Development Control Committee 10/04/17

Application CM/51/15: Mineral Extraction from land North of North Park

Fig 1. Proposed revision to boundaries on north-east section

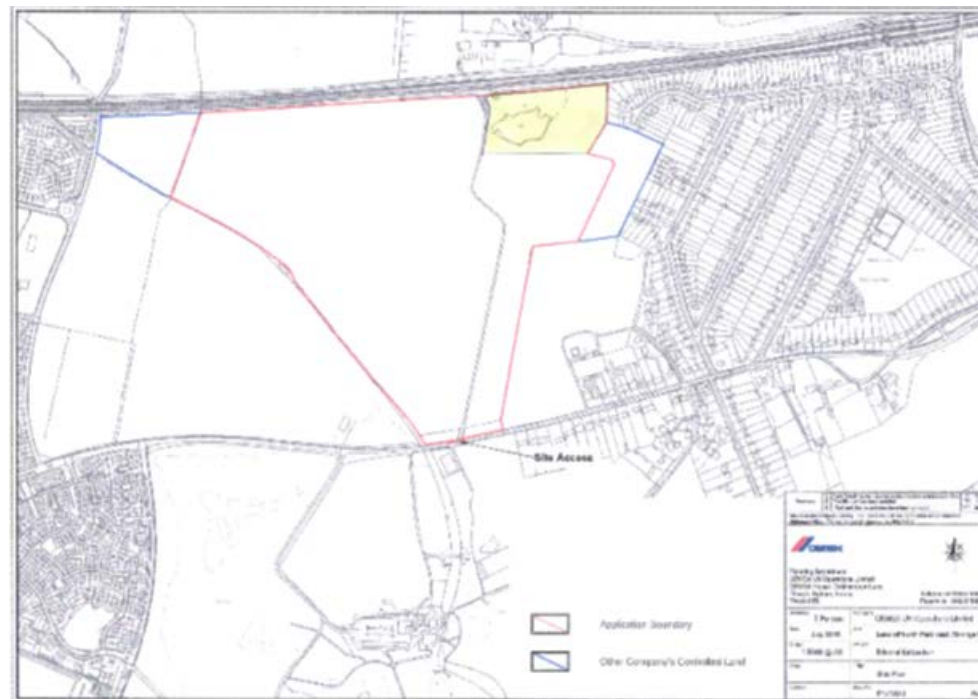
On this basis, we strongly object to the proposal and urge the Committee reject it, particularly given the needs for the site boundary to the north-east of the site to be redefined in accordance with **Fig. 1** and the removal of the concrete plant from the application.

- Improvements made to the wildlife habitat qualities of the hatched area of Fig 1 as part of Phase 1.
- Improved mitigation measures provided for the residents of Bathurst Walk

Area shaded yellow to be removed from the area for extraction of minerals.

CEMEX ACCESS

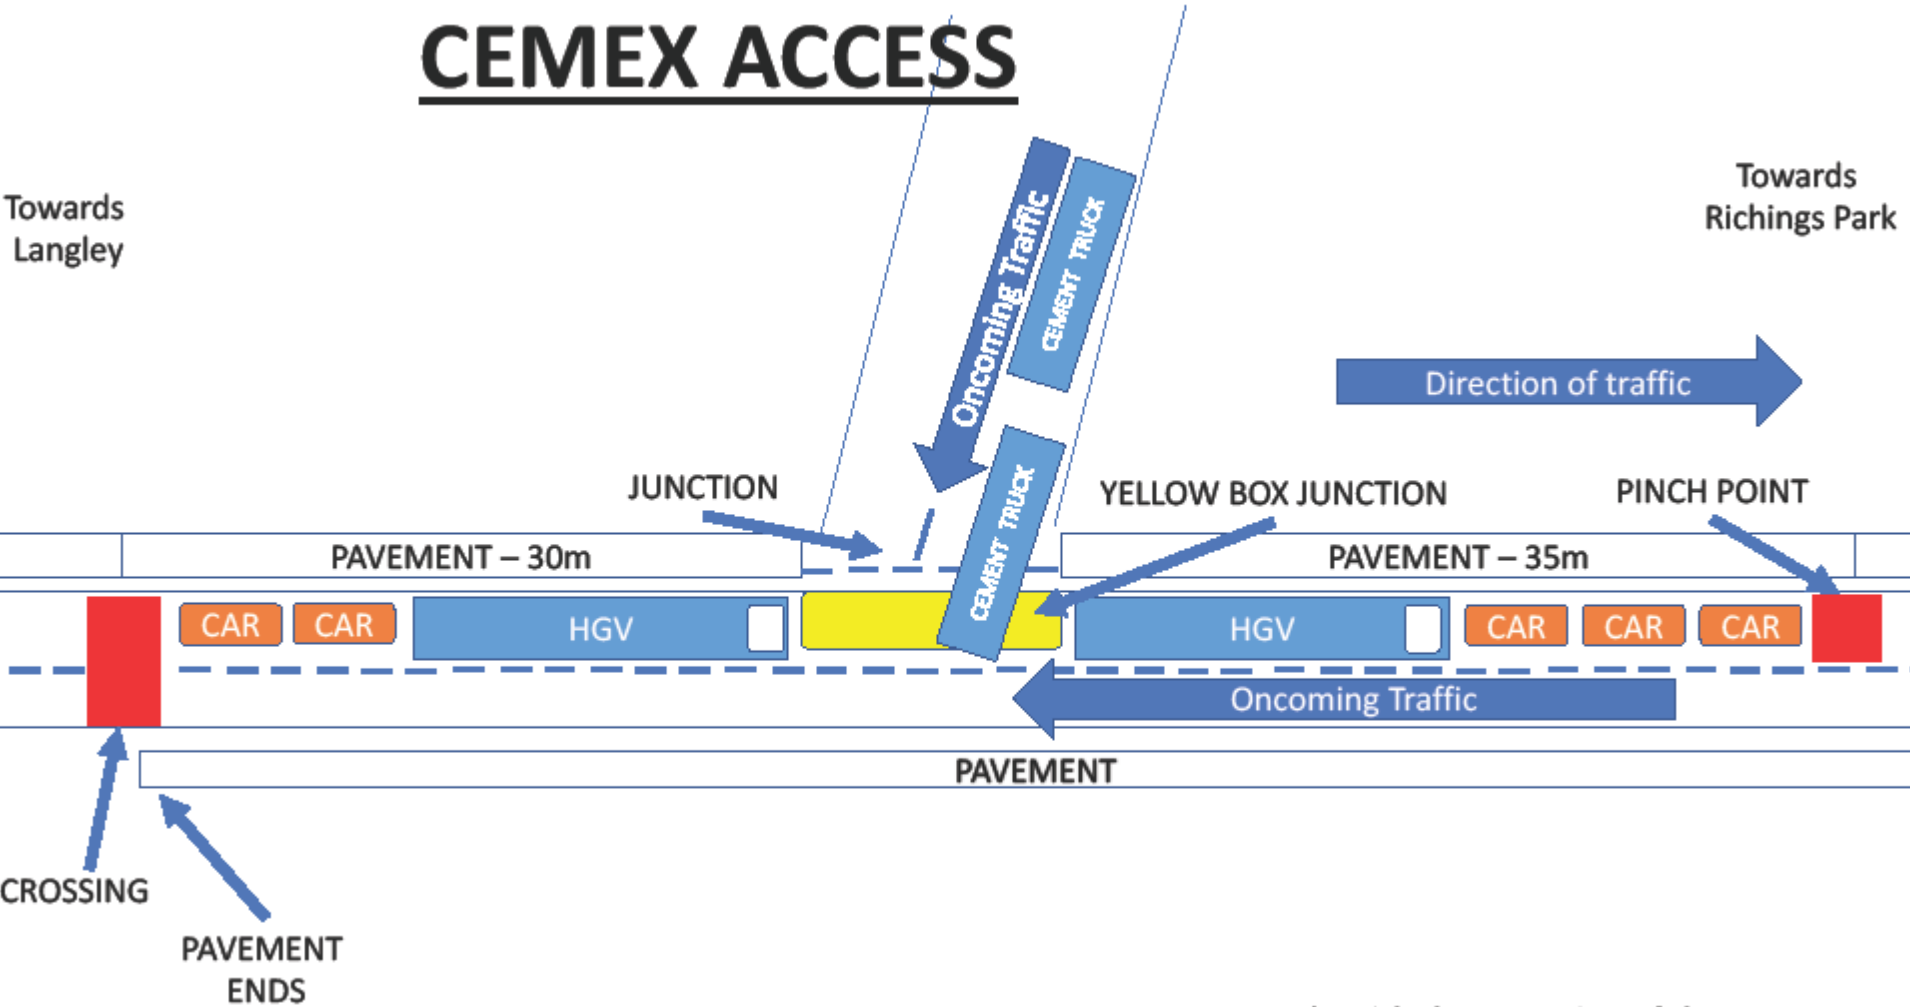
There is a ‘priority built-out’ or pinch point 35m to the east of the site access. (p 90 of Transport Assessment). The applicant states in the Transport Assessment that the queue length from this is typically reaches 11 vehicles and that this would not cross the access.

- This statement is totally inaccurate as can be seen from the attached photo and plan, where it is clear that only 3 queuing 16.6m HGVs would obstruct the entrance.

- The traffic data used to derive this conclusion is outdated and the conclusion therefore invalid.
- The footpath on the north side of North Park terminates at the bridge parapet, approximately 30 m west of the site entrance (see attached plan). Pedestrians must cross the road to the footpath on the south side at this point. There is no street lighting here to assist in dark winter mornings or afternoons.
- The applicant (Para 11.94; p70 of Planning Statement) concludes “*The potential effects of the development upon pedestrian delay and pedestrian amenity are considered to be insignificant.*”
- No assessment of pedestrian **safety** has been undertaken
- No consideration has been given to the risks to pedestrians crossing the road when vehicles are turning out of the site with vision restricted by queuing traffic into a line of traffic.
